REMARKS

Drawings

Method for Controlled Synchronization to an Astable Clock System, and Reception Unit Corresponding Thereto

Inventors: Hendrik Rotsch, et al.
Attorney Docket.: 071308.0160
Annotated Drawings Page 2 of 3

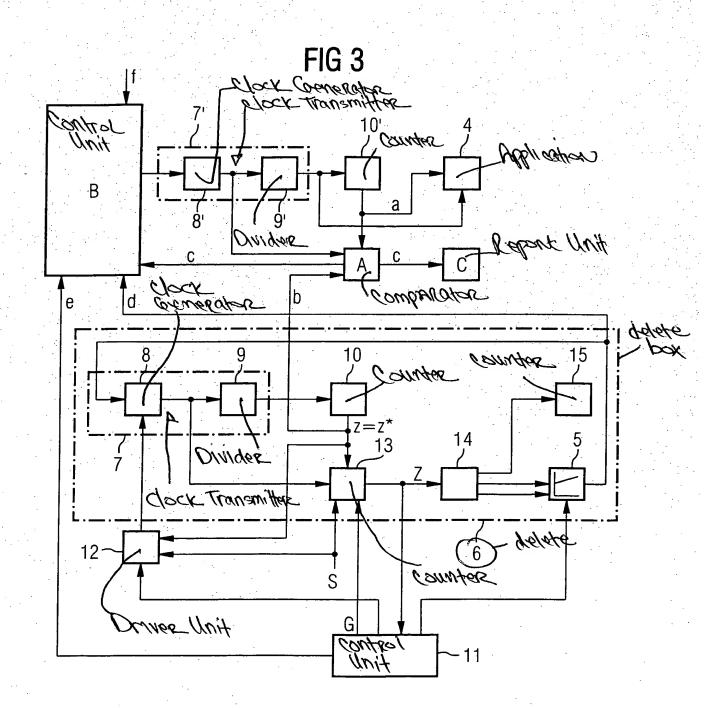
With respect to Fig. 3, an additional amendment has been made by removing the dotted box labeled with numeral "6" to put this figure in conformity with Fig. 2.
